REMARKS

ECCENTRICITY CORRECTION DATA...02/23/2004
Takamatsu et al.- 0941.68963
Greer, Burns & Crain, Ltd. (Patrick G. Burns)
Marked-Up/Annotated Sheet

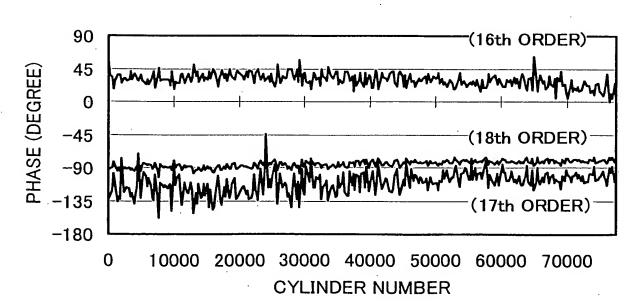
Please approve the drawing changes as shown in red on the attached marked-up copies of Figs. 1-3. A separate Letter to the Draftsman indicating the same proposed changes are also enclosed.

As a preliminary matter, with respect to the drawings, Applicants have included herewith marked-up copies of Figs. 1-3, with the proposed changes in red. As can be seen from the proposed changes, Applicants have corrected the informalities to which the Examiner has objected. Approval of the proposed drawing changes is respectfully requested.
